**Special Standard
PUD Zoning District**

Project Name: GRANDVIEW PHASE II

PCD File No.: PUDSP-236

Exhibit of Deviation Location

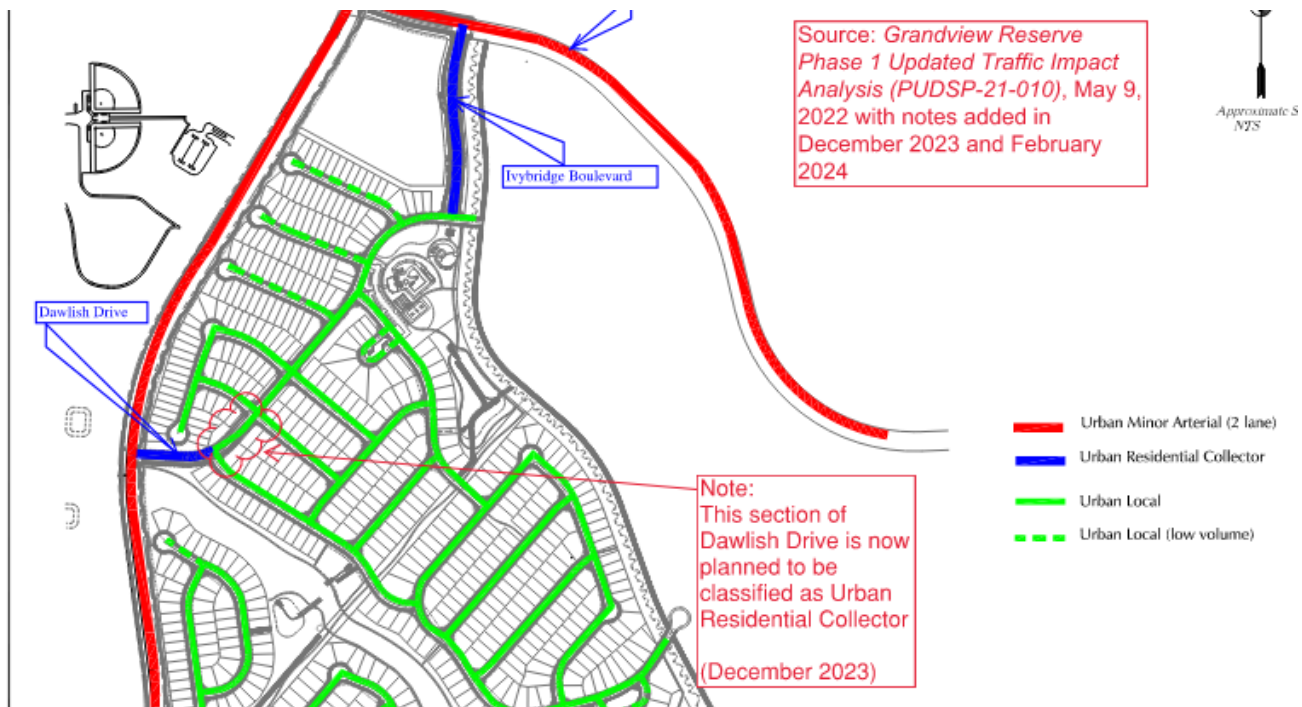
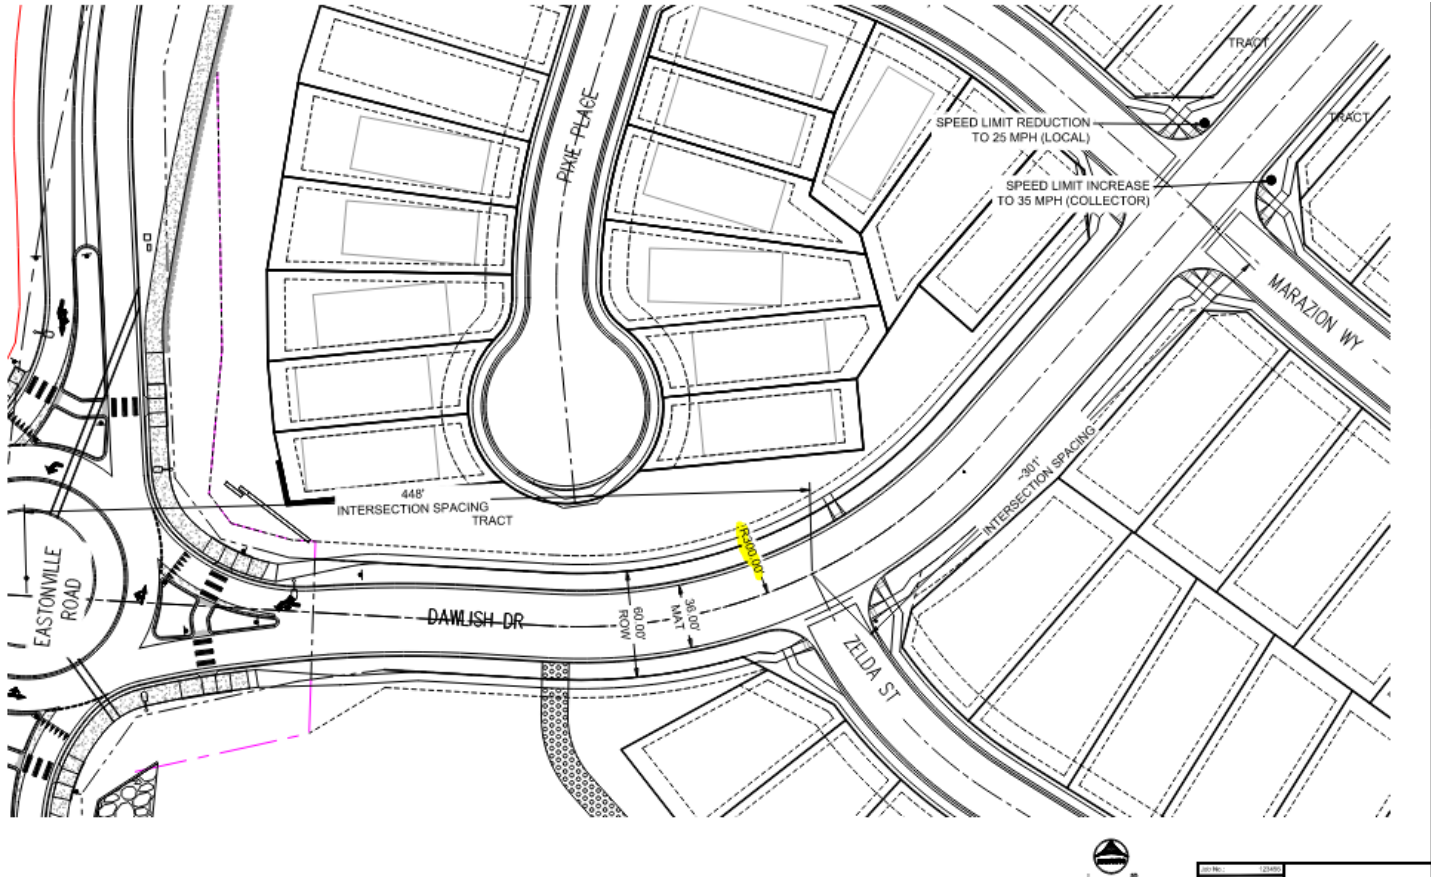
Deviation from Table 2-7. The table lists a minimum 565' centerline radius for An Urban Residential Collector Roadway. The deviation proposes a centerline radius of 301' at one location along the collector segment at the western end of Dawlish Drive, between Eastonville Road and Marazion Way. Dawlish Drive was previously classified as an Urban Local roadway in the approved Phase 1 Traffic Study, but changes to the layout of Phase 2 to the east have led to a classification change based on ADT being slightly over the 3,000 VPD threshold.

- 1.) The request saves one lot and maintains previously approved configuration with Phase 1 PUD.
- 2.) The pavement and Right of Way widths are designed to Urban Residential Collector standards to adequately convey traffic volumes as intended with the standard design of Urban Residential Collectors.
- 3.) Vehicular safety will be improved by reducing the speed to 25 mph (Local Roadway) entering the curve. Pedestrian safety is increased by shifting the sidewalk further from the roadway throughout this section.
- 4.) The resulting deviation of centerline radius will not impact maintenance and associated cost.
- 5.) The deviation has minimal impact to aesthetic appearance, however, more landscaping in the larger tree lawn will improve aesthetics.

Exhibit of Deviation Location

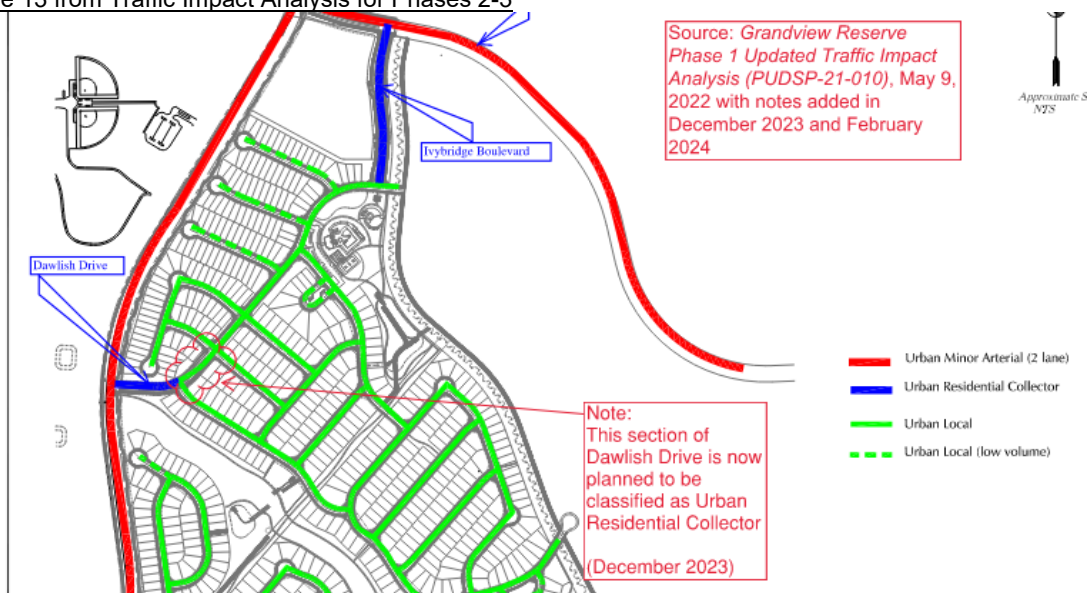
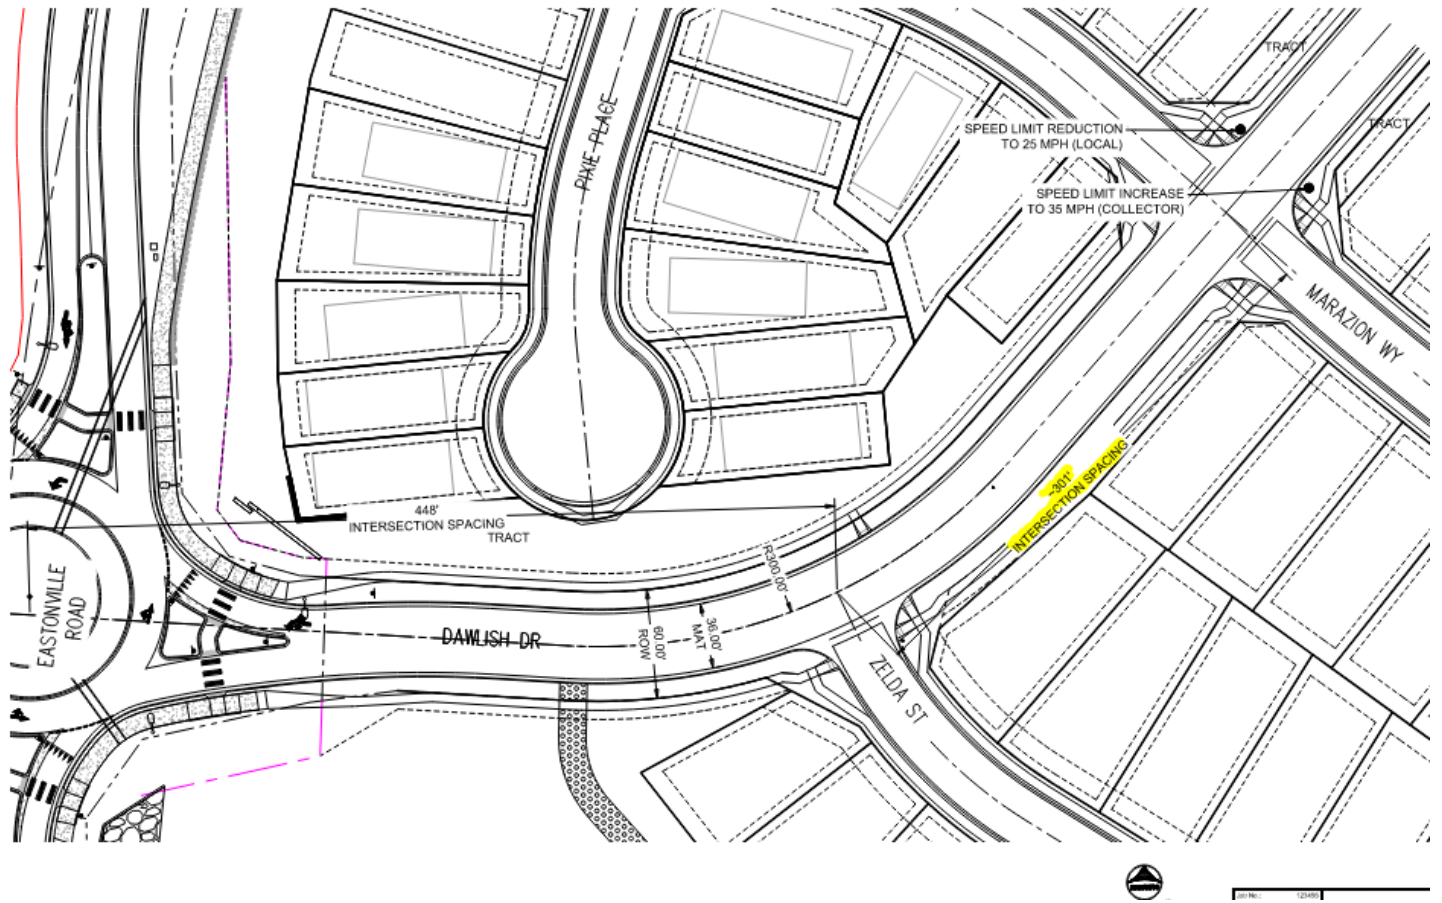
Deviation from Table 2-7. The table lists a minimum 330' intersection spacing for an Urban Residential Collector Roadway intersecting a local roadway. The deviation proposes an intersection spacing of approximately 301' along the collector segment at the western end of Dawlish Drive between the Zelda Street (Local) and Marazion Way (Local) intersections. Dawlish Drive was previously classified as an Urban Local roadway in the approved Phase 1 Traffic Study, but changes to the layout of Phase 2 to the east have led to a classification change based on ADT being slightly over the 3,000 VPD threshold.

- 1.) The deviation is not based on financial considerations and is intended to maintain the previously approved configuration with Phase 1 PUD.
- 2.) The pavement and Right of Way widths are designed to Urban Residential Collector standards to adequately convey traffic volumes as intended with the standard design of Urban Residential Collectors.
- 3.) Vehicular safety will be improved by reducing the speed to 25 mph (Local Roadway) prior to entering the segment of Dawlish between Zelda Street and Marazion Way. Pedestrian safety is increased by shifting the sidewalk further from the roadway throughout this section.
- 4.) The resulting deviation of intersection spacing at one location has an insignificant impact maintenance and associated cost.
- 5.) The deviation has minimal impact to aesthetic appearance, however, more landscaping in the larger tree lawn will improve aesthetics.

Modified Roadway Section

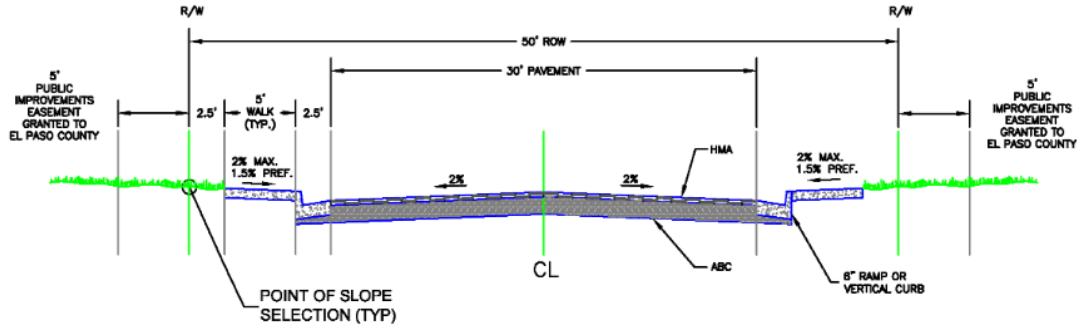
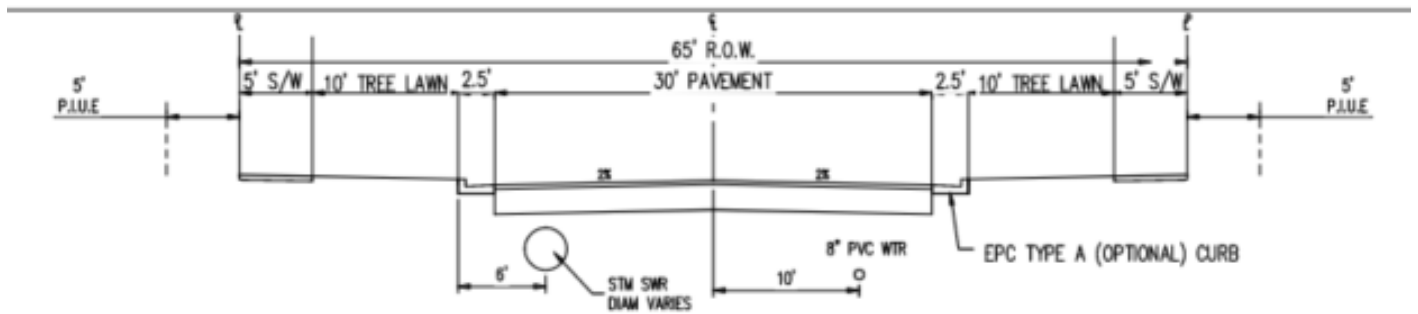
Deviation from Figure SD_2-2: Typical Urban Local Roadway Cross Section. The figure shows the typical cross section with a right of way width of 50', attached 5' sidewalk, and a tree lawn of 2.5'. The Modified Urban Local Roadway Cross Section proposes a right of way width of 65' to encompass a larger 10' tree lawn and detached 5' sidewalk. The standard and modified cross sections are shown below. This Deviation is for Grange Tr. only.

- 1.) The deviation increases financial obligations for the roadway by adding increased landscaping area.
- 2.) The proposed cross section is comparable to county standards by providing sufficient lanes to safely convey peak volumes of traffic as determined by the traffic study.
- 3.) The deviation promotes pedestrian safety by increasing separation of the sidewalk from the roadway.
- 4.) The deviation will have insignificant effects on maintenance as the mat width remains the same.
- 5.) The deviation provides more usable green space/landscaping for a more aesthetically pleasing entrance to the subdivision.

GRANGE TR.
MODIFIED NEIGHBORHOOD STREET: 65' R.O.W. STREET SECTION
DETACHED SIDEWALK(URBAN LOCAL)
 N.T.S.
